February 21, 2020

In response to your request for information related to the basing of the F-35A aircraft at Truax Field, I provide the following:

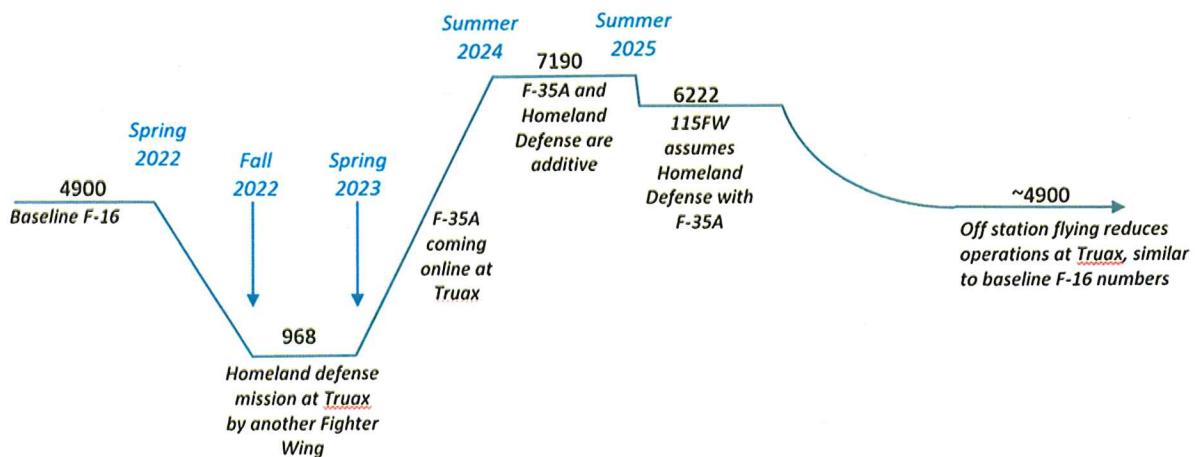
4. Please provide a detailed timeline and explanation of how the “alert mission” would be handled with the arrival of the F-35s; if F-16s are drawn down with the arrival of F-35s as stated in the EIS, what is the actual increase in flights that could be expected during the transition between fleets.

Comment #35) Commenters raised some questions regarding how long it will be until the alert mission changes to F-35A and operations decrease at the 115 FW.

FEIS Response: "As stated in the EIS (Section 2.2.1.2), the F-16s will continue to conduct the alert mission until the F-35A aircraft are alert mission-capable, which is currently an undetermined length of time. Also refer to Comment #4g" in question 3 above.

At the time of this letter, it is not currently known if the alert mission will be at Truax Field or not during the conversion to F-35. Since that is not known, the EIS conservatively assumes that the alert mission will continue at Truax Field until the F-35 is alert mission capable.

This graphic depicts how the number of local operations may fluctuate during the conversion to the F-35. The numbers used are from the FEIS.
